Appl. No. 09/876,290  
Amtd. Dated August 23, 2005  
Reply to Office Action of March 23, 2005

**AMENDMENTS TO THE DRAWINGS:**

## ASSEMBLY JIG AND MANUFACTURING METHOD OF MULTILAYER SEMICONDUCTOR DEVICE

**FIG.2(d)**

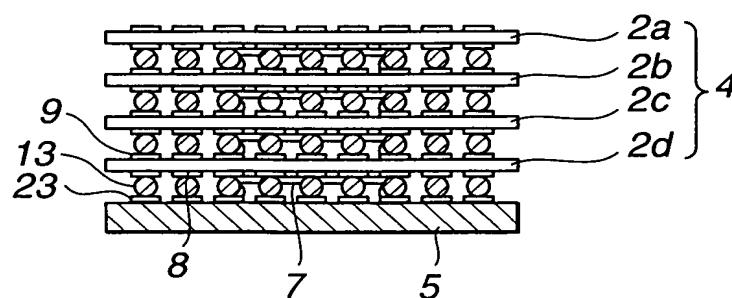
The attached sheet of drawings include changes to Fig. 2(d).

The sheet which includes Fig. 2(d) replaces the original sheet including Figs. 2(a)-2(f). The lead line extensions requested by the Examiner have been added.

Fig. 2(d) has been amended to comport with the Examiner's objection under 37 CFR 1.84.

**FIG.2 (f)**

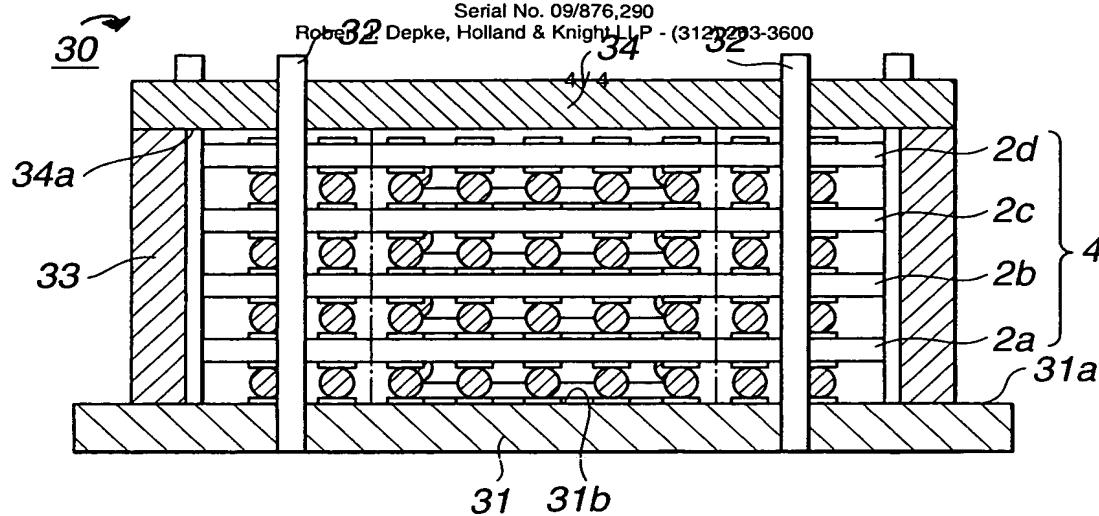
The attached sheet of drawings also include changes to Fig. 2(f), 5(a), and 5(b).

The sheet which includes Fig. 2(f) replaces the original sheet including Figs. 2(a)-2(f). The sheet which includes Figs. 5(a) and 5(b) replaces the original sheet including Figs. 5(a0, 5(b), and 6. The lead lines requested by the Examiner have been added.

In regard to the Examiners objections to the drawings under 37 CFR 1.84(q), Applicants have added the request lead lines for references 1 and 30.

## FIG.5(a)

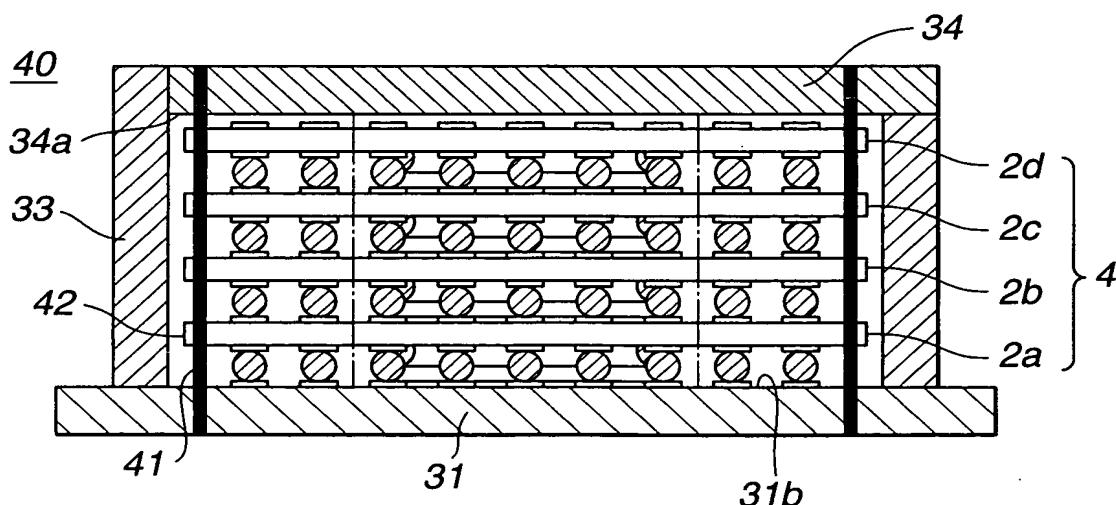
In regard to claim 12, support for this claim can be found starting at the top of page 20 of Applicant's disclosure, and in Fig. 5(b), which shows positioning pins 32 arranged adjacent to and in contact with sides of the stacked semiconductor modules 2.
